UNITED STATES
DEPARTMENT OF THE INTERIOR
BUREAU OF LAND MANAGEMENT

FORM APPROVED
OMB NO. 1004-0135
Expires: July 31, 2010**SUNDRY NOTICES AND REPORTS ON WELLS**
*Do not use this form for proposals to drill or to re-enter an abandoned well. Use form 3160-3 (APD) for such proposals.***SUBMIT IN TRIPLICATE - Other instructions on reverse side.**

PECOS DISTRICT CONDITIONS OF APPROVAL

OPERATOR'S NAME:	XTO Energy, Inc.
LEASE NO.:	NMNM-19246
WELL NAME & NO.:	Nash Unit 45H
SURFACE HOLE FOOTAGE:	0550' FNL & 1250' FWL
BOTTOM HOLE FOOTAGE:	0330' FNL & 1980' FWL Sec. 06, T. 23 S., R 30 E.
LOCATION:	Section 18, T. 23 S., R 30 E., NMPM
COUNTY:	Eddy County, New Mexico

GRADE D PRESSURE TEST CERTIFICATE

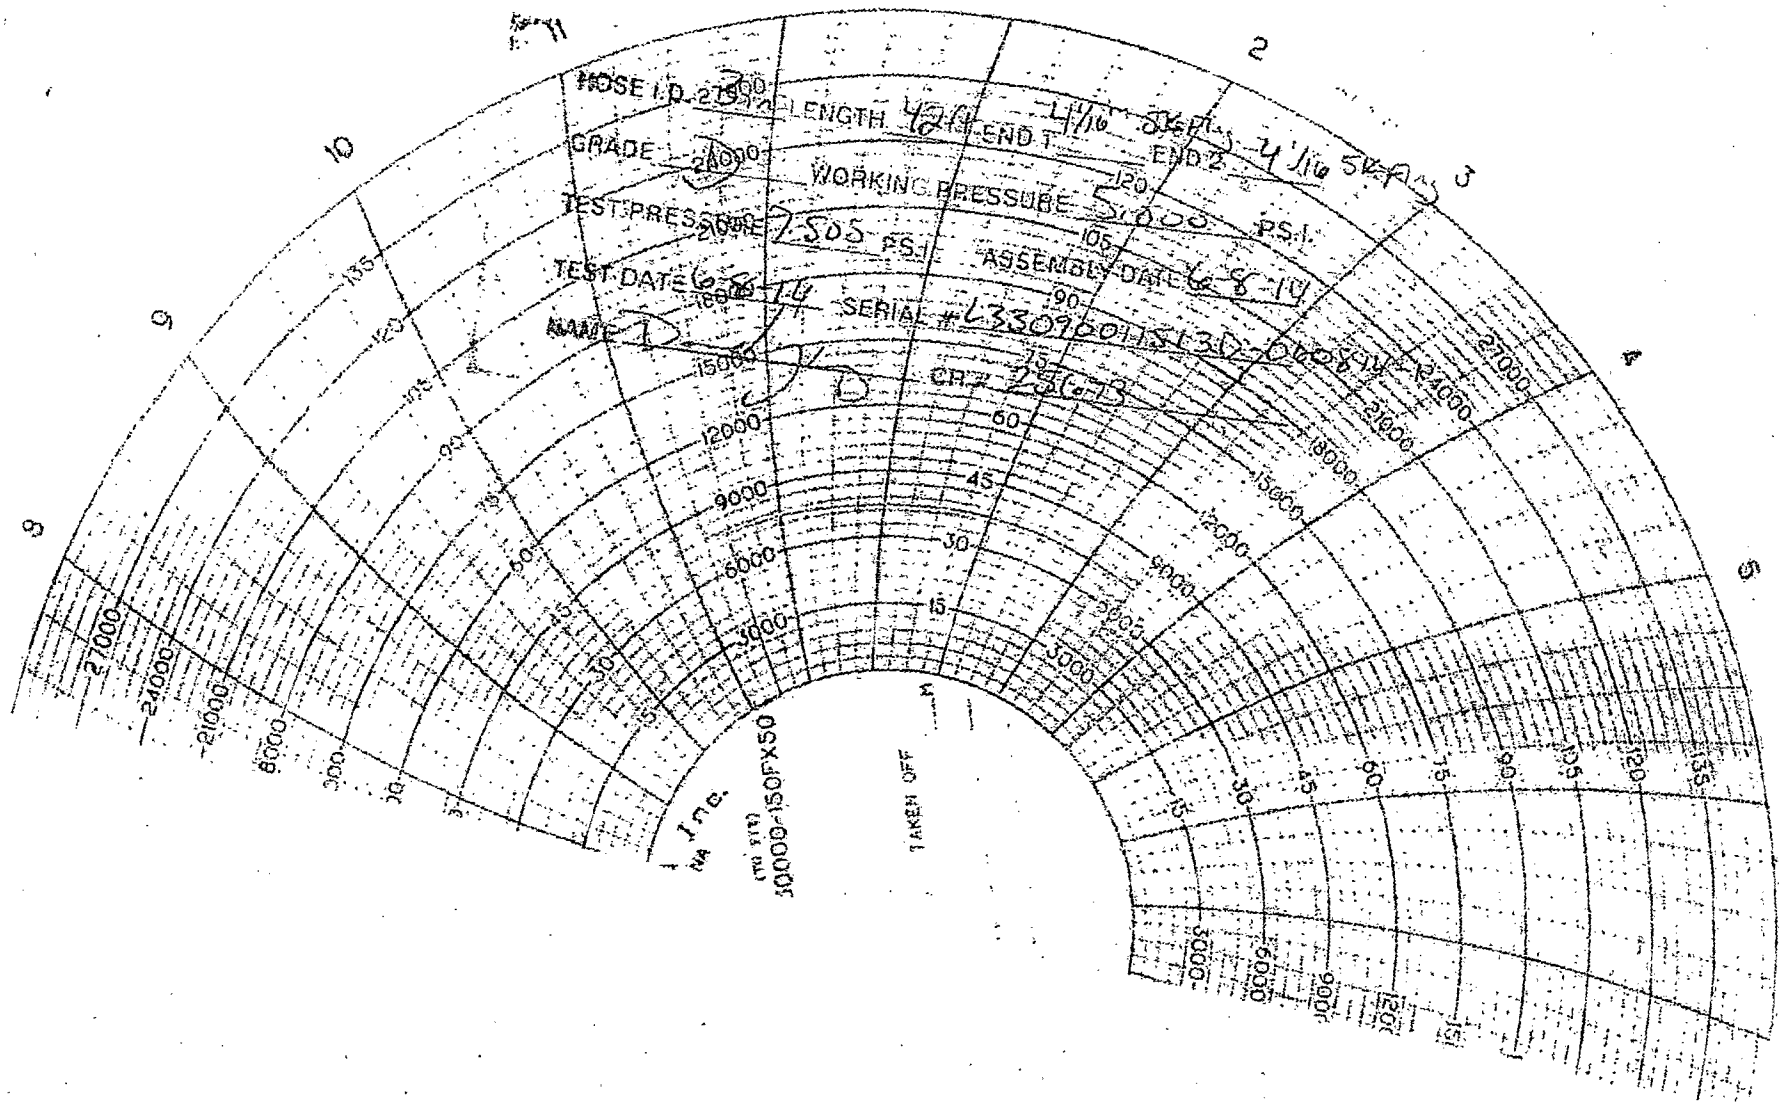
3)XTO Energy requests a variance from the requirements to use straight hard line as the choke line and instead use a flex hose. Pioneer 33 is outfitted with a Gates E&S flex hose rated to 5,000 psi working pressure (serial# D-060814-1). See attached for test certificate and copy of the pressure test chart.

2. Variance approved to use flex line from BOP to choke manifold. Check condition of flexible line from BOP to choke manifold, replace if exterior is damaged or if line fails test. Line to be as straight as possible with no hard bends and is to be anchored according to Manufacturer's requirements. The flexible hose can be exchanged with a hose of equal size and equal or greater pressure rating. **Anchor requirements, specification sheet and hydrostatic pressure test certification matching the hose in service, to be onsite for review.** If the BLM inspector questions the straightness of the hose, a BLM engineer will be contacted and will review in the field or via picture supplied by inspector to determine if changes are required (operator shall expect delays if this occurs).
